SECTION 12A PLANNING APPLICATION NO. Y/YL-TYST/12

Further Information Submission – Consolidated Revised Document

To rezone the application site from "Comprehensive Development Area" and "Green Belt" to "Residential (Group A) 4" and to
Amend the Notes of the zone applicable to the site

Response to Departmental Comments Table

Dwg No. Figure 2-2

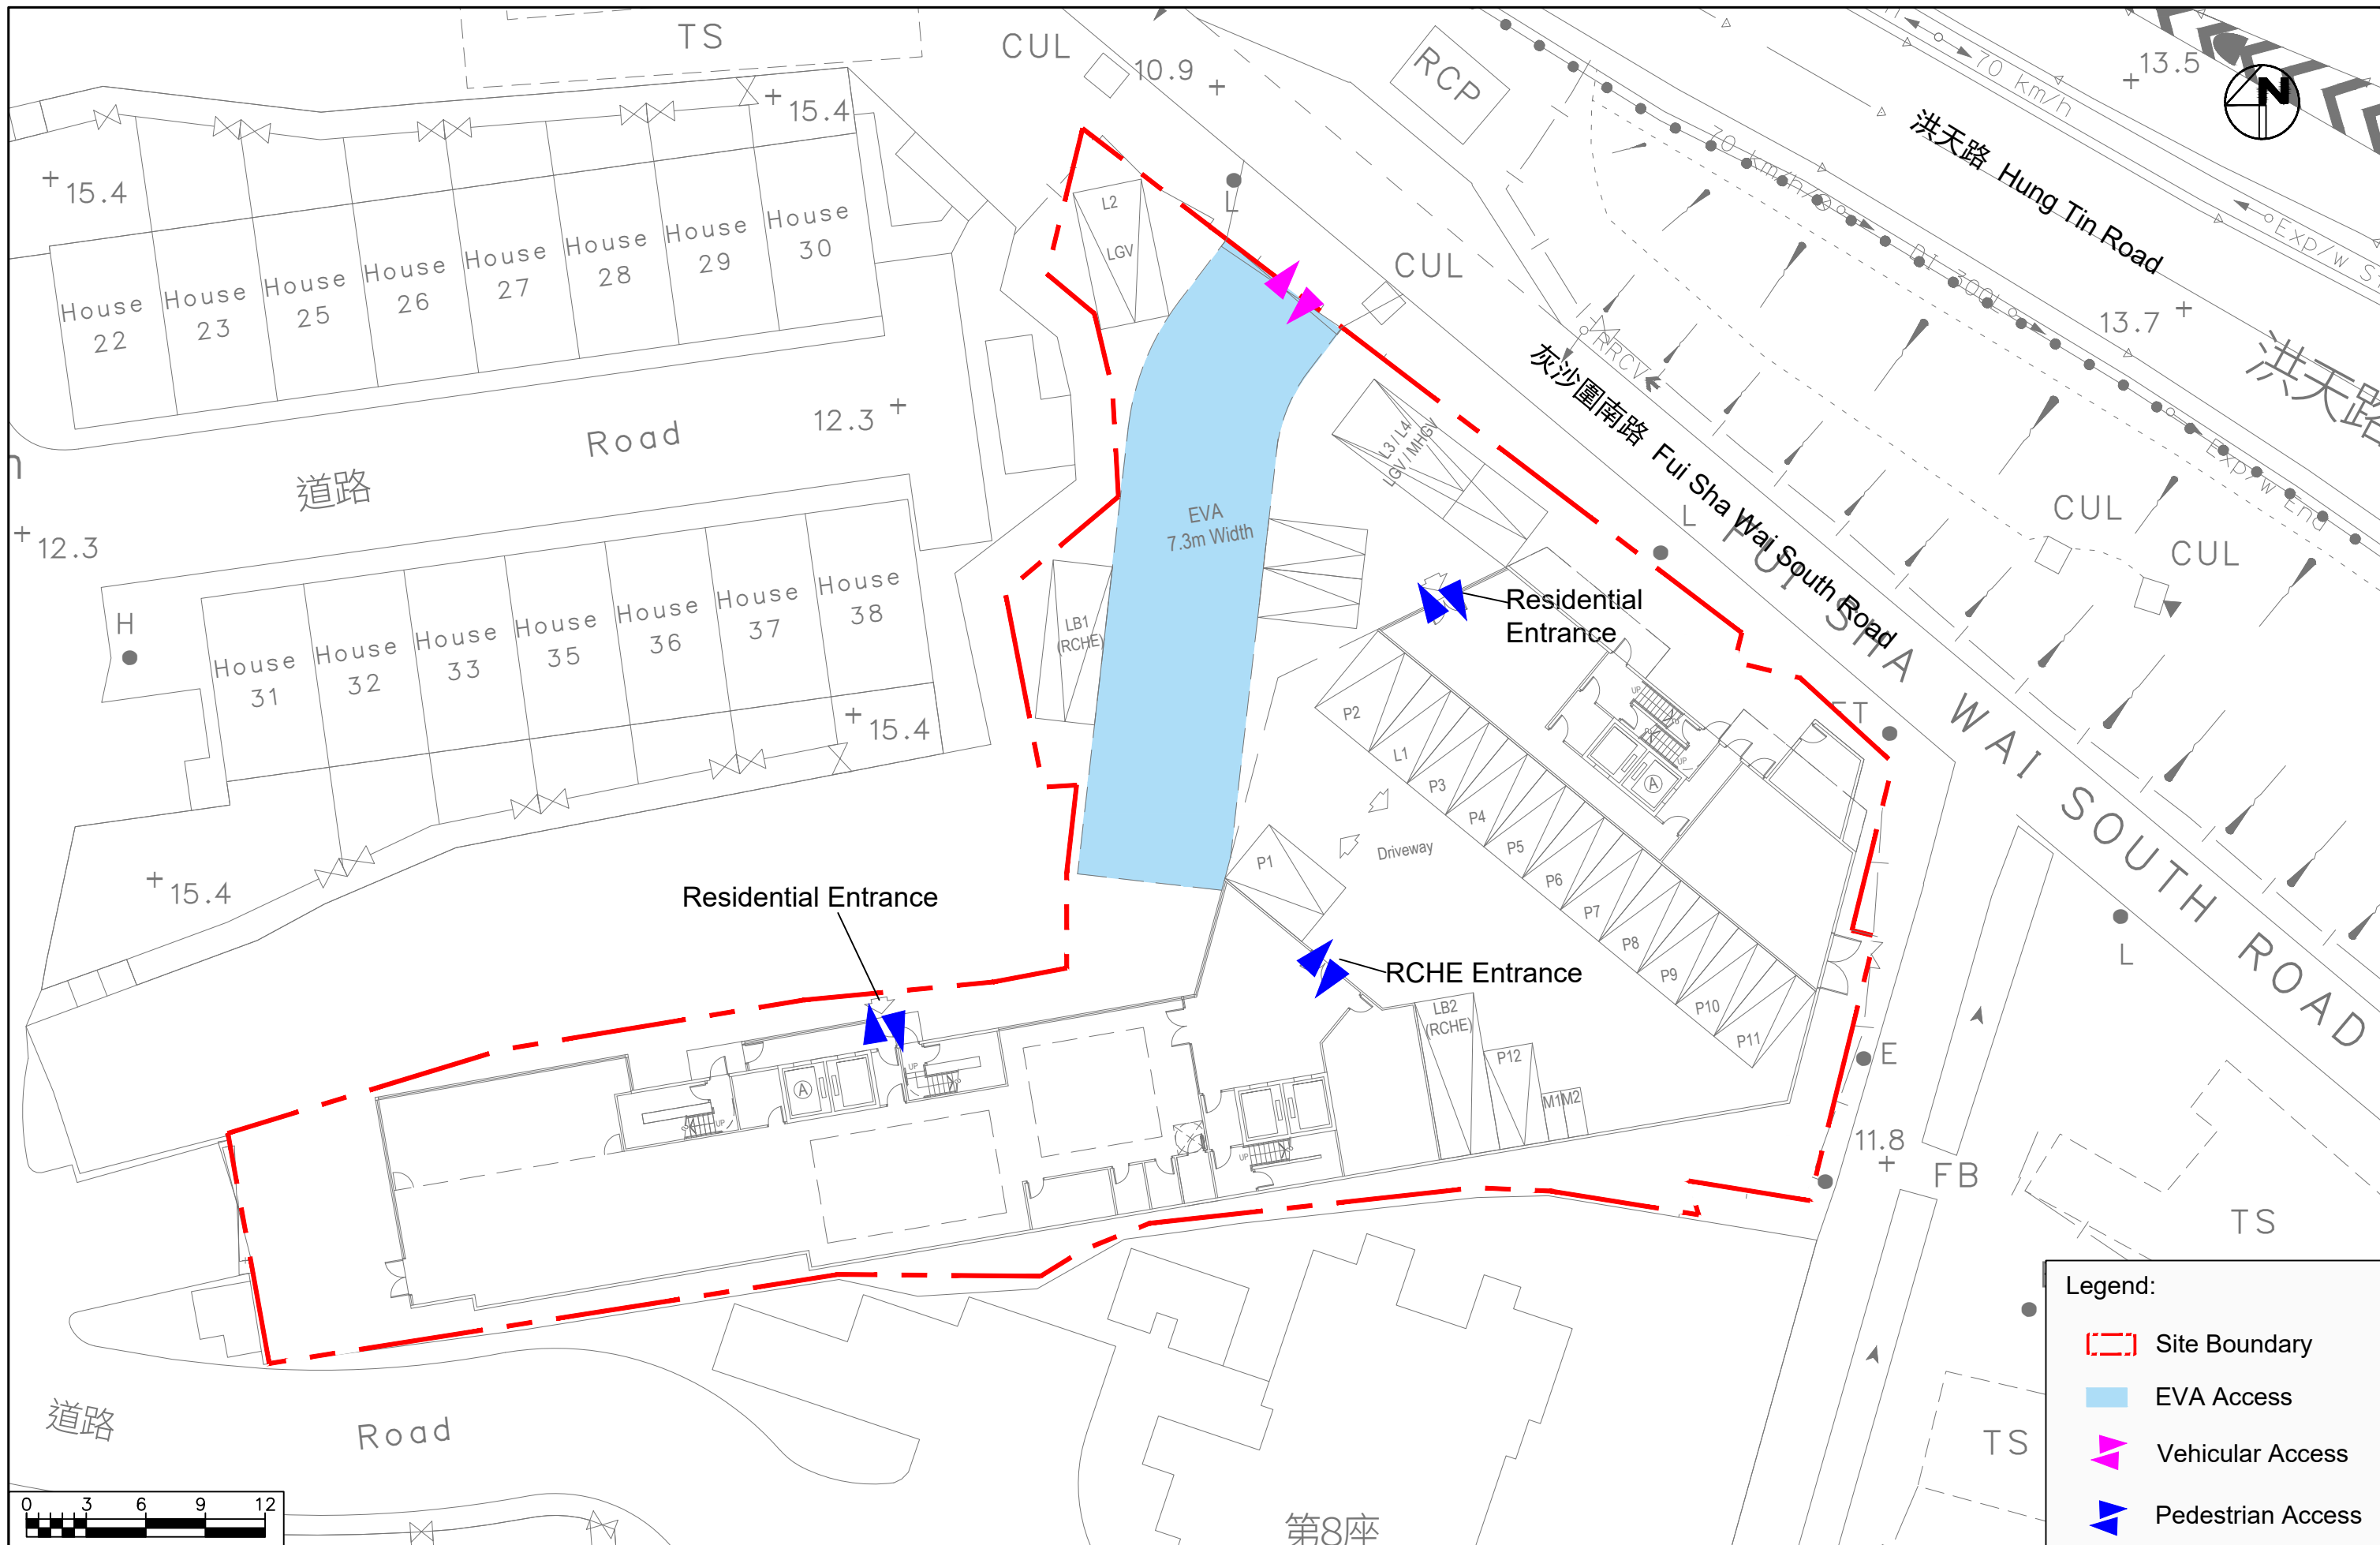
a) Please supplement the indicative direction of carpark exhaust outlet to demonstrate it is directed away from the nearby ASRs as far as practicable.	Noted and the indicative direction of carpark exhaust outlet has been provided in the revised Figure 2-2 .
